BLOOMINGTON HISTORIC PRESERVATION COMMISSION

AGENDA

COA-17-33

212 S. Grant St. (Greater Restaurant Row)
Petitioner: Annex Student Living

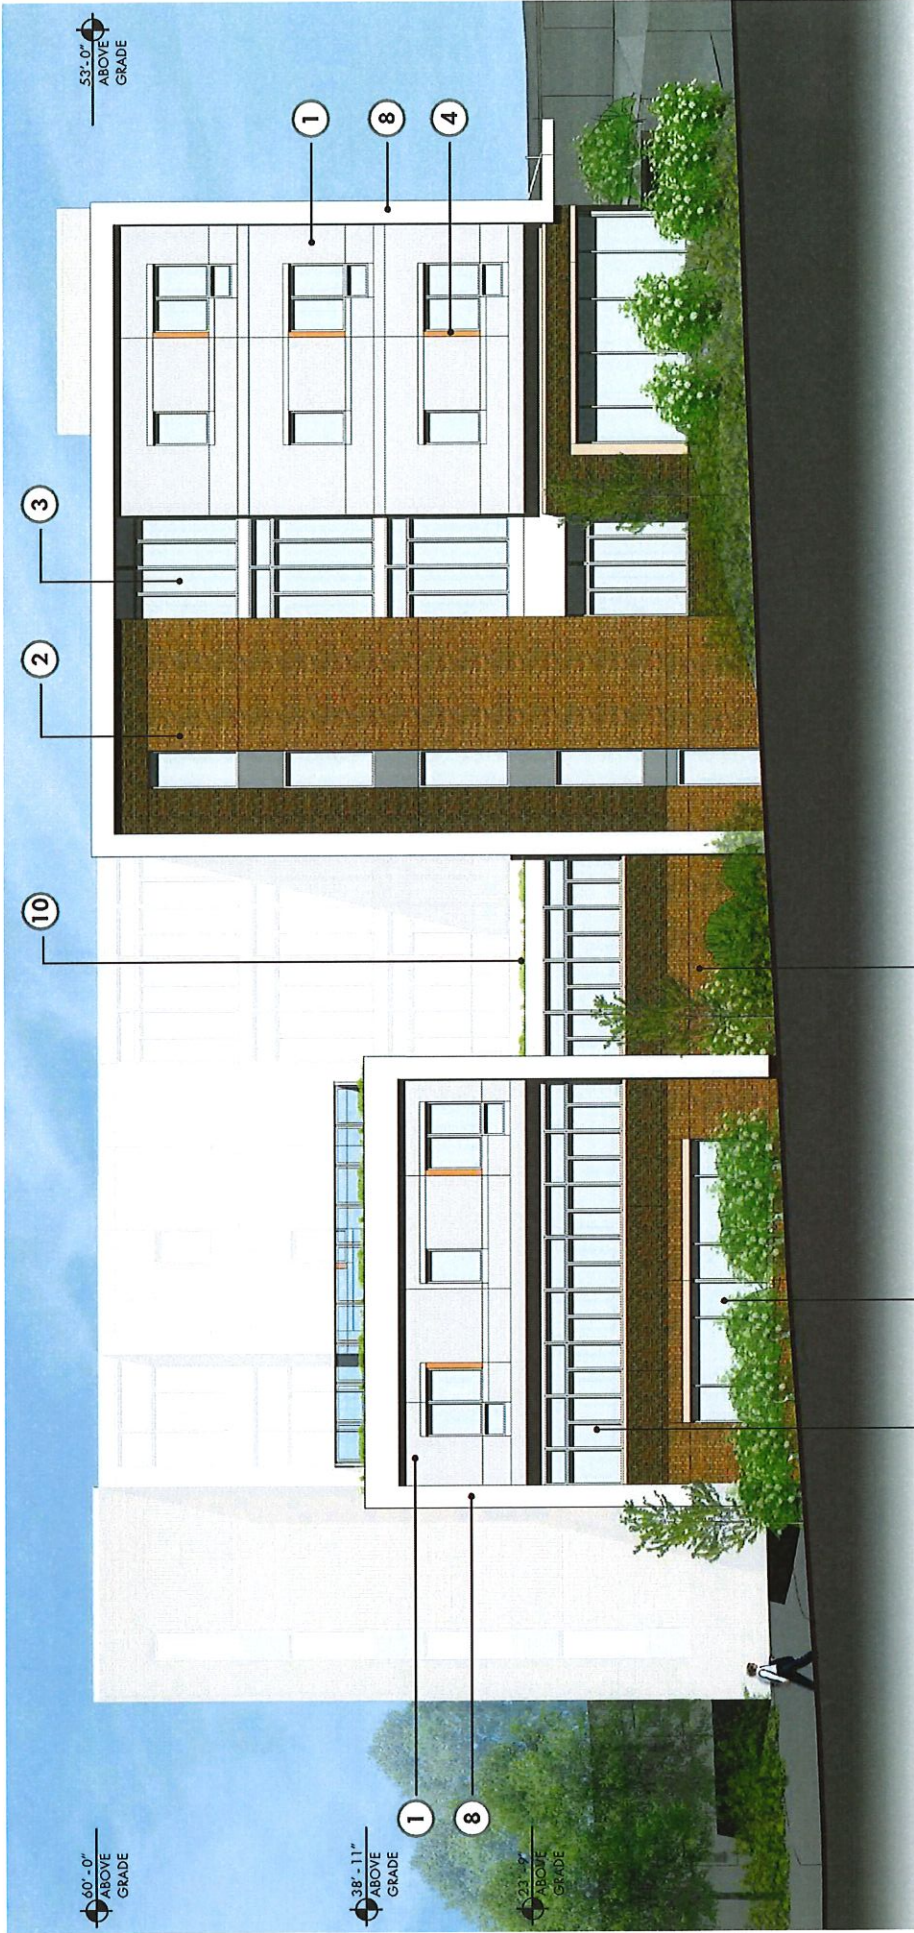
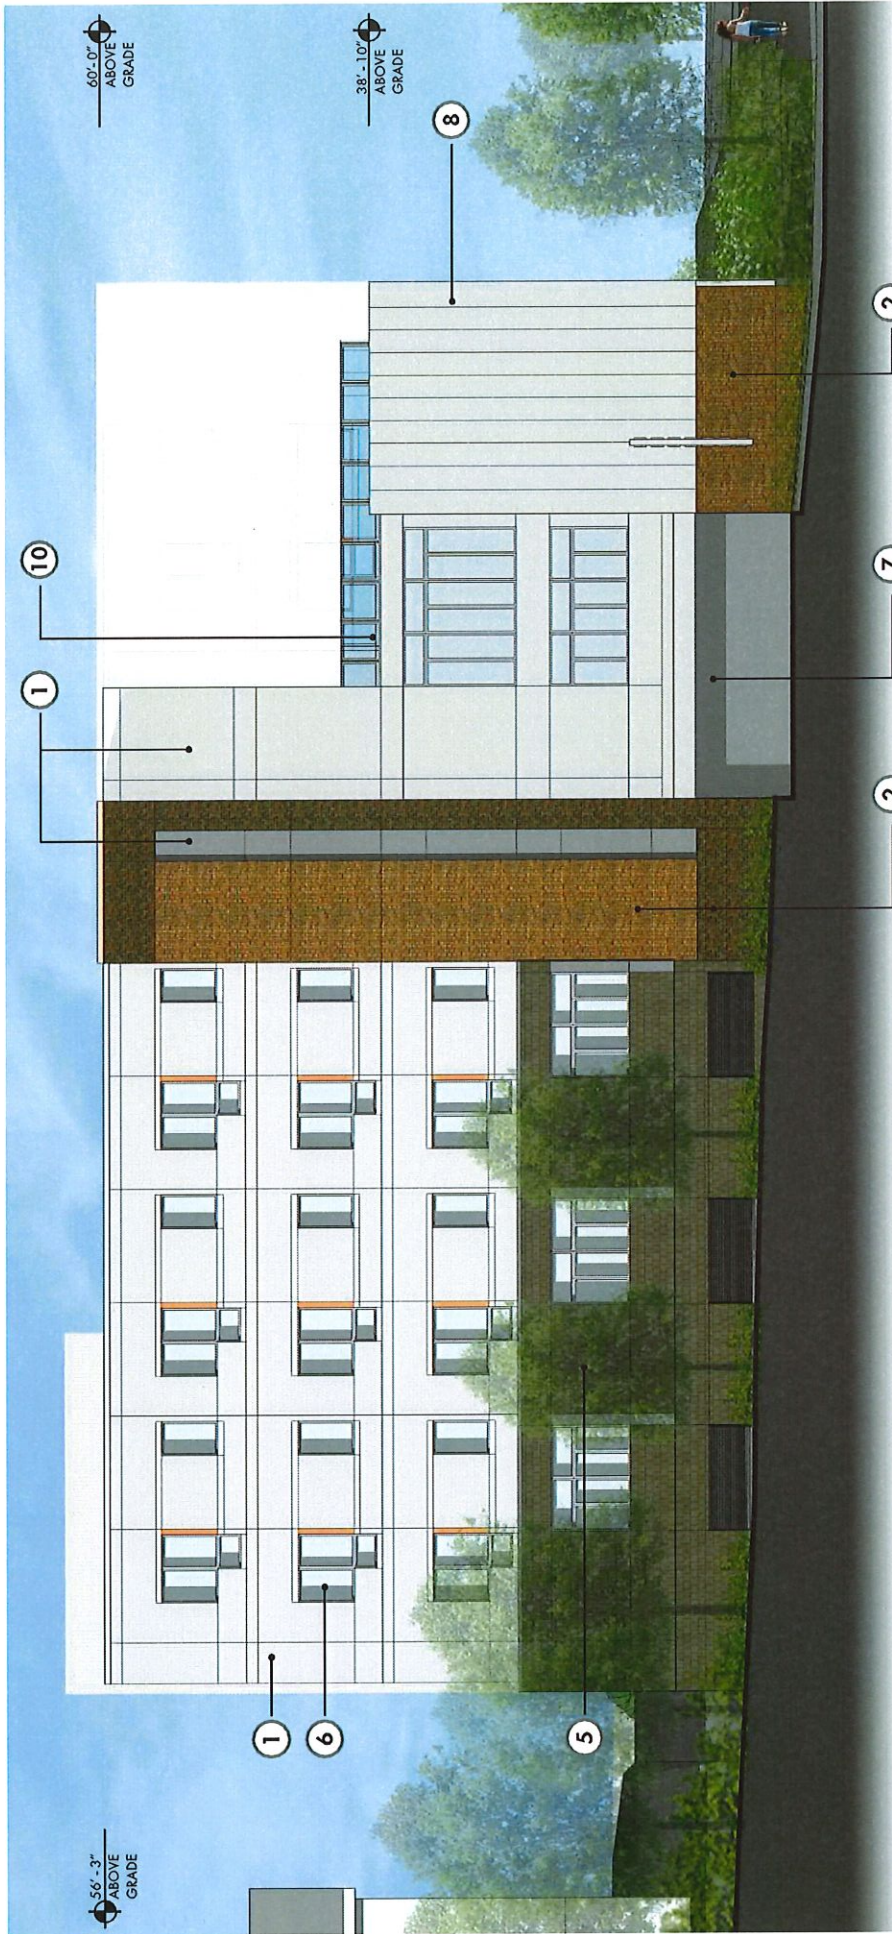
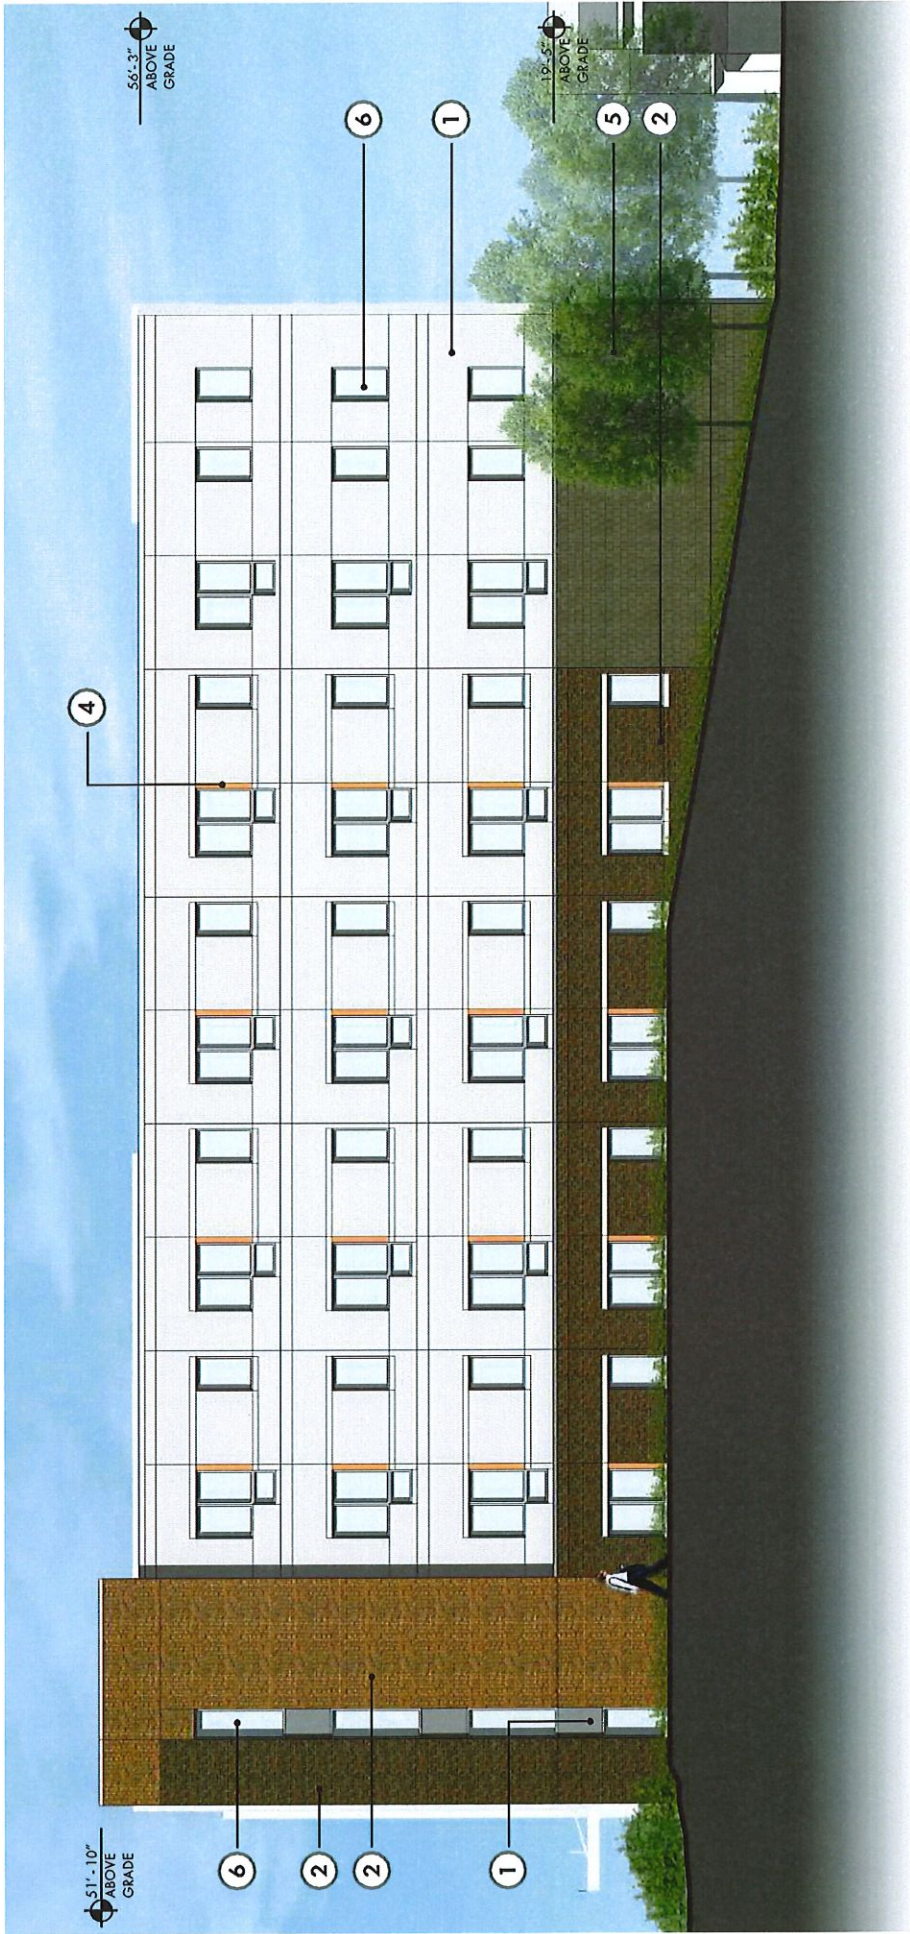
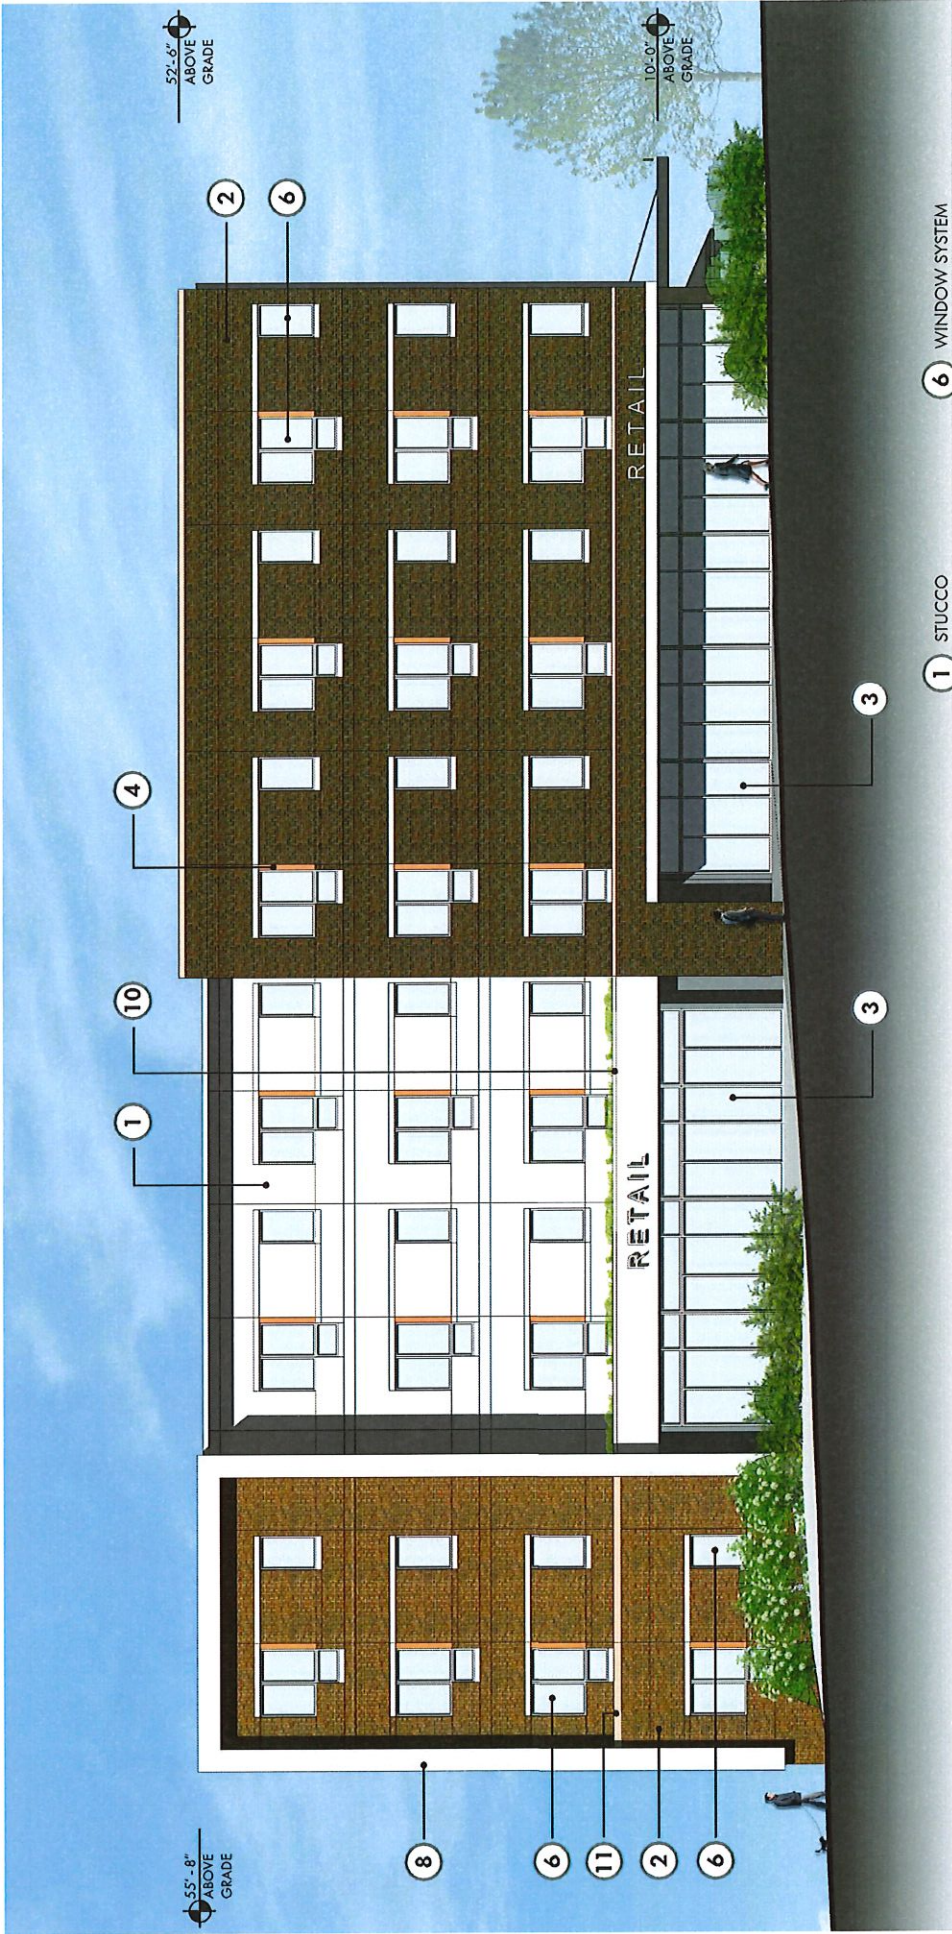
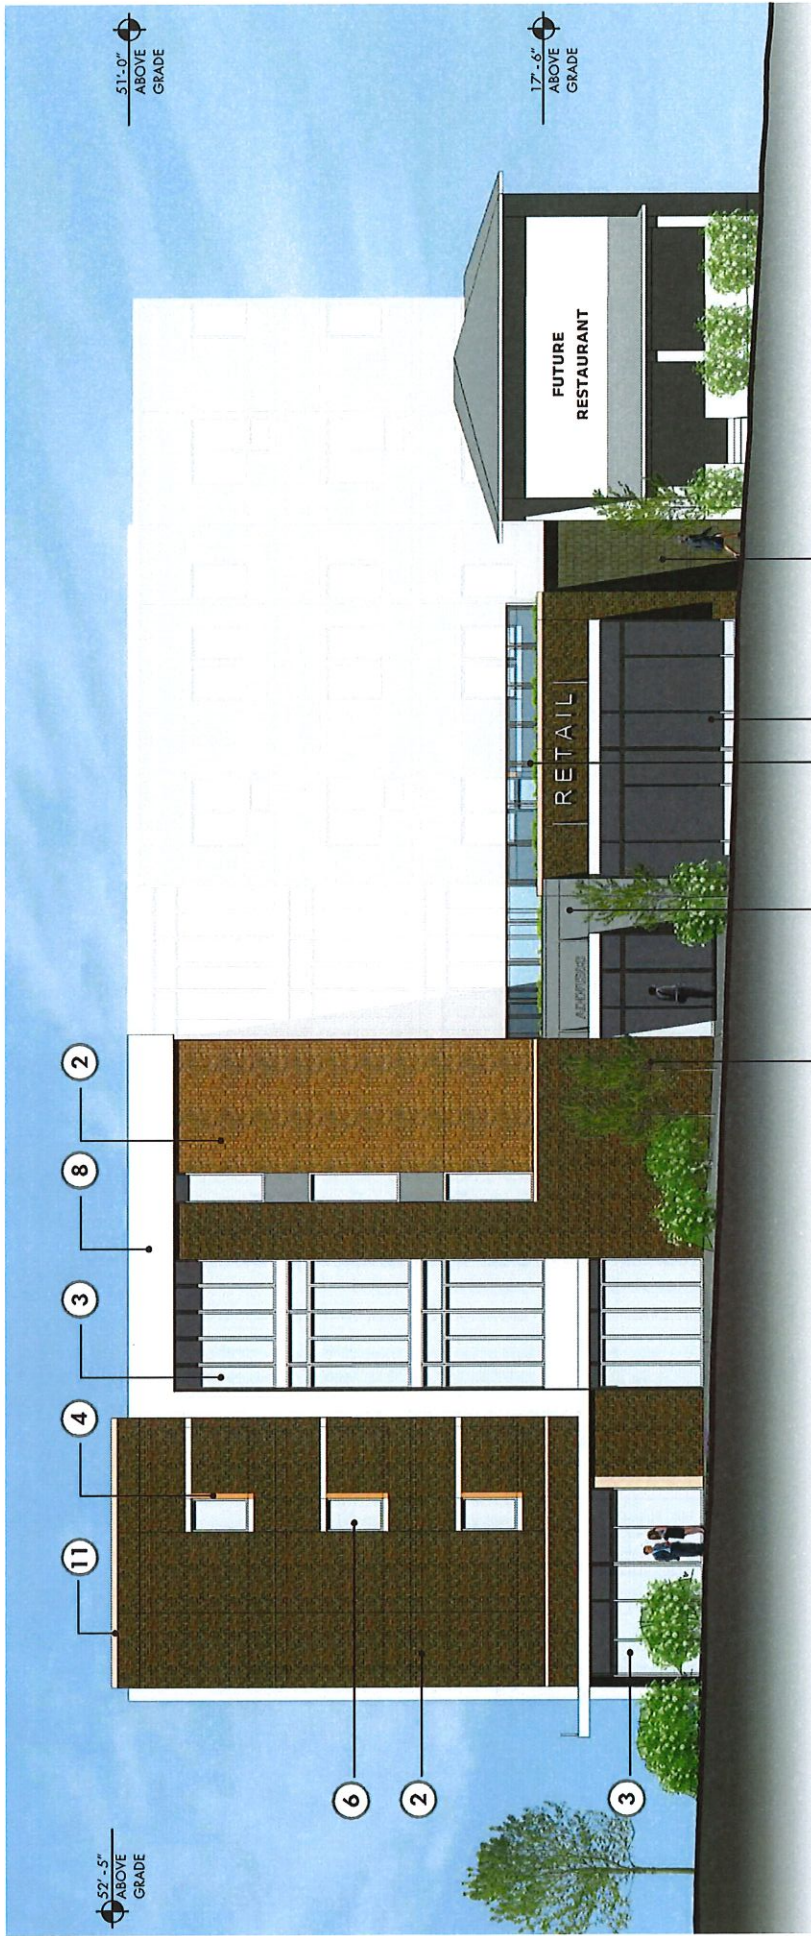
Standard 9 from the SOI Standards notes three important review considerations for new infill construction: “characteristics of the property, differentiation of the new work from the old, and compatibility with existing fabric in terms of materials, features, size, scale, and proportions and massing.” Things to be considered in context with the rest of the historic district are how the new construction fits by site placement, height, massing, scale, materials, development patterns and architectural characteristics such as ornamentation and fenestration. The portion of the project in our purview breaks away

from many of the district's characteristics such as the rhythm of the residential form and fenestration, material connectivity, and residential character. This district's period of significance is primarily the late 1800s and early 1900s district. This proposed project shows no connection to the district other than having a residential feel front yard street/pedestrian connection adjacent to the house on 212 S. Grant St. As the district's character as a single family residential pattern is still well established, staff is recommending denial of the permit according to incompatibility for the aforementioned criteria within the Greater Restaurant Row Historic District.
